BNL-MOX-2009-001

Risk Assessment of Red Oil Excursions in the MOX Facility

7.5 Quantitative Assessment of ROE.....	7-5
7.6 Conclusions.....	7-7
7.1 References.....	7-8
Appendix A Failure Rate Data, Event Trees and Fault Trees.....	A-1
Appendix B Red Oil Safety Strategy and TBP Prevention Strategy By Vessel in the AP Processing Units.....	B-1
Appendix C Response to the Review Comments by Dr. Dana Powers.....	C-1

Figure 3-1. Conditions for a red oil explosion to occur

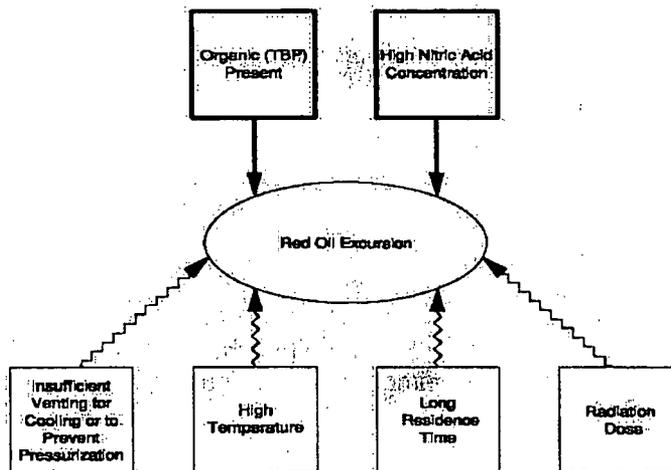
8. The diagram in figure 3-1 specifically neglects radiation dose as a contributor to the formation of red oil. I think this can be misleading. One misleading comment arises immediately following where it is asserted that contact between the solvent or diluent, in this case hydrogenated propylene tetramer, cannot lead to the formation of explosive compounds. This may be true for an idealized system, but radiolytic processes can intrude. Hydrocarbon radiolysis has not received the attention that has been devoted to water radiolysis. Hydrocarbons can still undergo reactions including the formation of unsaturated and even oxygenated species. There does not appear to be abundant data for the diluent to be used here, there are data for diluents used in the past. Most troublesome is the radiolytic formation of alkenes that can subsequently react with radiolytic species such as ozone or peroxide.

Figure 5-8. Slab settler dimensions and locations of the levels of the light and heavy phases.

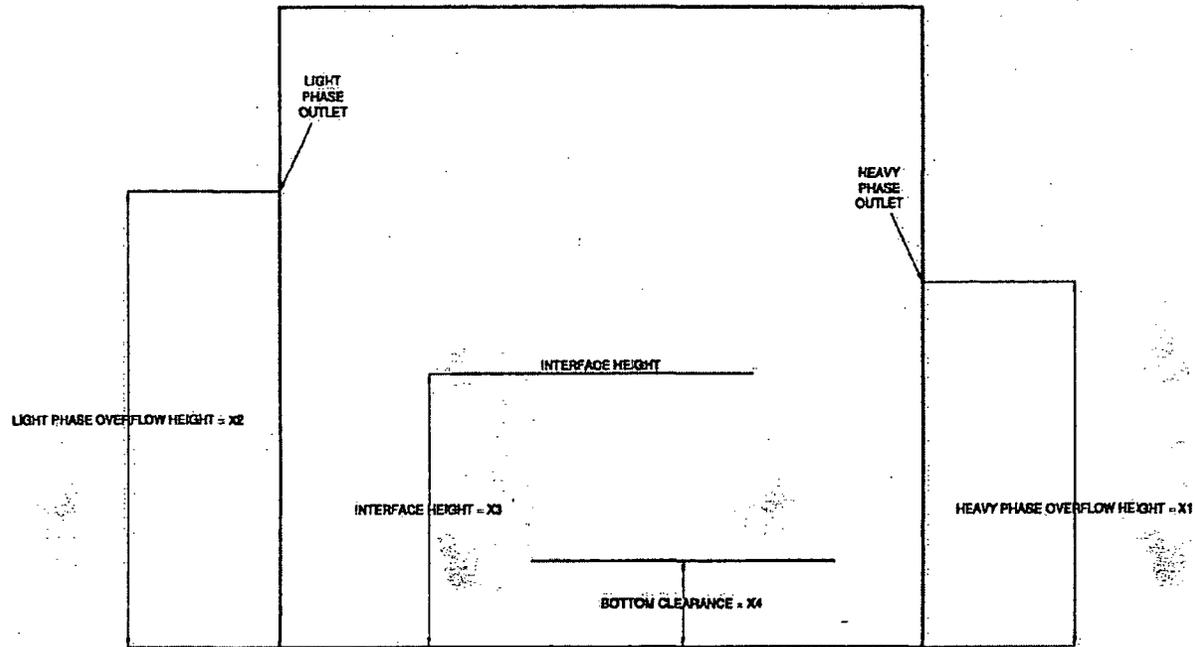
43. Figure 5-8 is essentially unreadable. If you puzzle out the figure, it really does not help to understand the equation. Terms need to be better defined in the equation. Table 5-2 is a mystery. What are the cases being examined here?
